## **Product Change Notice (PCN)**

PCN Number: PCN-0451211-01

Product(s) Affected: PJ-059B

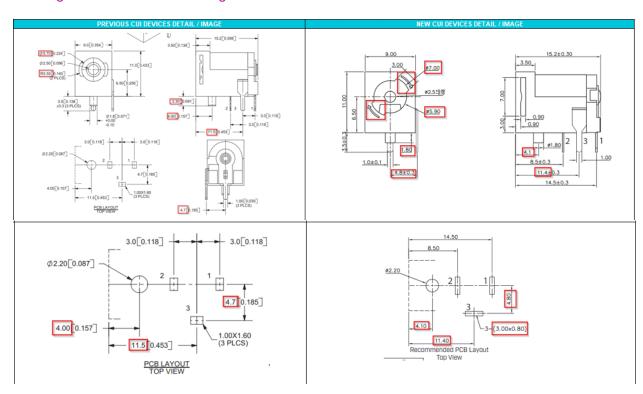
Description of Change: Minor Housing and footprint differences. Material Change on the housing and terminals. See image Below

DESCRIPTION	MATERIAL	PLATING/COLOR
center pin	brass	nickel
terminal 1	brass t=0.30	tin
terminal 2	bronze t=0.25	tin
terminal 3	brass t=0.30	tin
cover	PBT (UL94V-0)	black
housing	PBT (UL94V-0)	black
